Completion of Heritage Conservation Work: Moiso Residence, 2101 Clarke Street (formerly 2614 St. Johns Street)

Item	Conservation Recommendation <i>(summary based on the Heritage Conservation Plan Nov 2015 Rev July 2016)</i>	Substantial Completion Review Notes <i>(Review on Monday, 15 June 2020)</i>

Completion of Heritage Conservation Work: Siddall Residence, 2901 St. Johns Street

Completion of Heritage Conservation Work: Sutherland Residence, 2133 St. Andrews Street

Figure 3 and 4: Detail photos showing textured lumber applications at window casing and watertable.

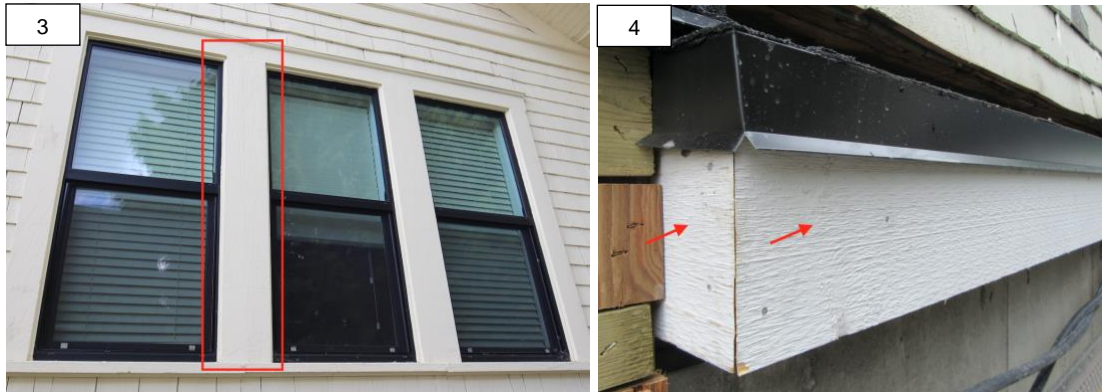
5.4.2	WOOD SIDING (Restoration) <ul style="list-style-type: none"> Retain cedar shingle siding and restore in-place where possible. Replace any damaged cedar shingle siding to match existing in material, size, profile. Combed or textured lumber, vinyl or fibre cement siding are not acceptable replacement materials on the historic house. Install new cedar shingles at the basement level closely matching the originals in overall 	Comments: <ol style="list-style-type: none"> Cedar shingle siding was retained and restored as required. Textured lumber was identified at a number of locations including watertable and window casings at basement level. Note that there was no consultation with the Heritage Consultant prior to installation. Cedar shingle siding of appropriate size and

dimensions and installation pattern.	dimensions installed at the basement level. 4. Wood siding restoration work is substantially complete.
5.4.3	WOOD TRIM (Restoration) <ul style="list-style-type: none"> Original trim that is in good or repairable condition may be retained, including window and door trim, fascia boards and bargeboards, and watertable. Cut out deteriorated trim sections and install matching trim board that is visually and physically compatible with the original. 	Comments: <ol style="list-style-type: none"> Original trim in good condition was retained and restored as required. Trim deteriorated beyond repair was replaced with textured lumber at a number of locations including watertable and window casings at basement level. Note that there was no consultation with the Heritage Consultant prior to installation. Wood trim restoration work is substantially complete.

Figure 6A: Internal brick chimney with corbelling before removal.

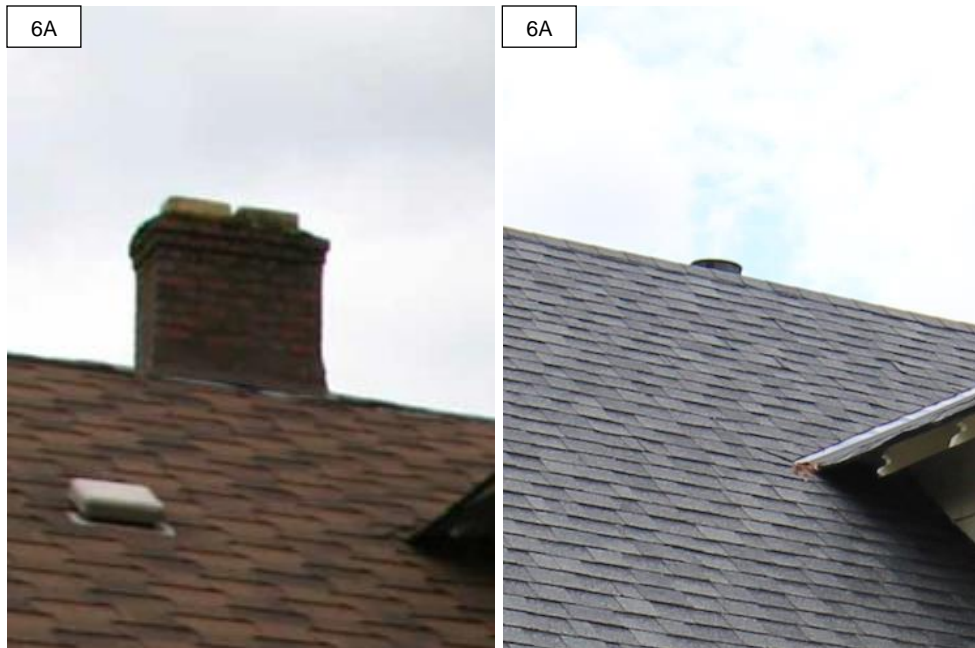
5.9	CHIMNEY (Restoration) <ul style="list-style-type: none"> • The brick chimney may be reconstructed in its original location and original dimensions as shown in photographs. Use red-common bricks and replicate corbelling detail. Install metal flashings at the base. 	Comments: <ol style="list-style-type: none"> 1. Brick chimney was not reconstructed in original dimensions or configuration. 2. Chimney restoration work is substantially complete.

Figure 3: Detail photo showing textured lumber application at window casing.

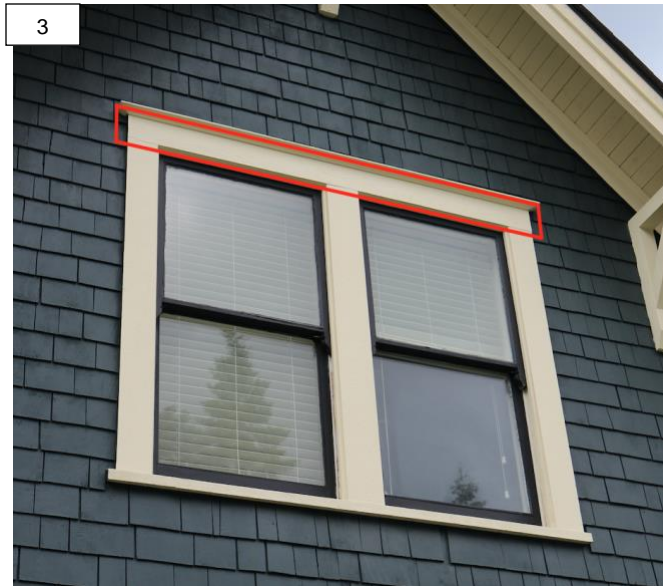
5.4.2	WOOD SIDING (Restoration) <ul style="list-style-type: none"> Retain lap and shingle siding and cornerboards and restore in-place. Replace any damaged lap siding to match existing in material, size, profile. Combed or textured lumber, vinyl or fibre cement 	Comments: <ol style="list-style-type: none"> Wood lap siding was retained and restored as required. Textured lumber was identified at a number of locations including watertable and window

<p>siding are not acceptable replacement materials on the historic house.</p> <ul style="list-style-type: none"> Install new cedar shingles at the basement level matching the originals in overall dimensions and installation pattern. 	<p>casings at basement level. Note that there was no consultation with the Heritage Consultant prior to installation.</p> <ol style="list-style-type: none"> Cedar shingle siding of appropriate size and dimensions installed at the basement level and gable walls. Wood siding restoration work is substantially complete.
